Docket No. 50-231

Change No. 8  
License No. DR-15

CHANGE NO. 8 TO THE TECHNICAL SPECIFICATIONS

PROVISIONAL OPERATING LICENSE NO. DR-15

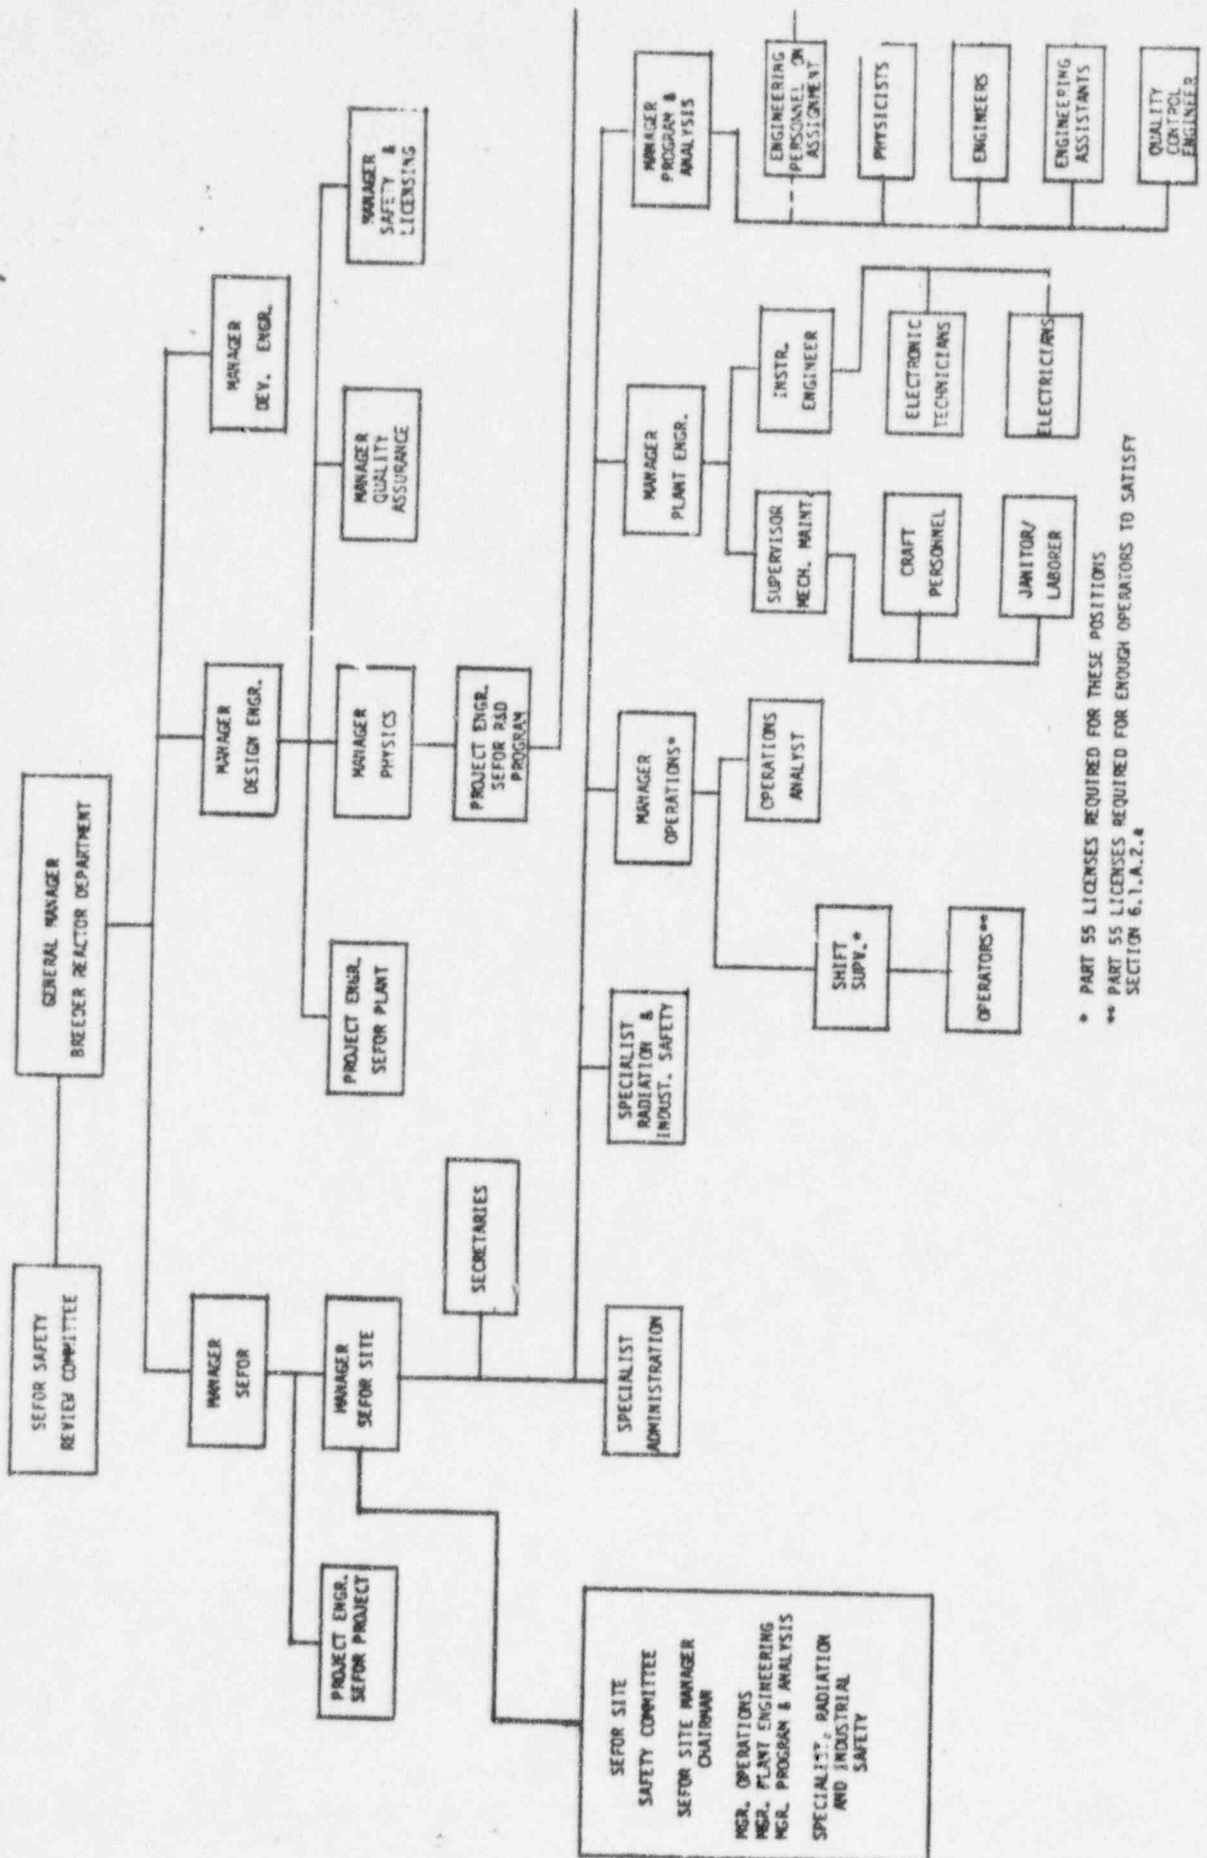
1. The organization for management, operation, and audit of SEFOR facility operations shall be as given in Figure 6-1. The overall full-time responsibility for operation of the SEFOR facility and compliance with these Technical Specifications shall reside in the SEFOR Site Manager. The Site Manager reports to the Manager, SEFOR, who in turn is responsible directly to the BRD General Manager. The BRD General Manager reports to the Nuclear Energy Division General Manager. As indicated in Figure 6-1, technical engineering assistance will be provided as necessary through the BRD Manager of Design Engineering.

- d. Personnel requiring Part 55 licenses shall be as indicated in Figure 6-1.
- 3. Qualifications with regard to education and operating experience for key supervisory personnel shall be as follows:
  - a. Manager, SEFOR Site
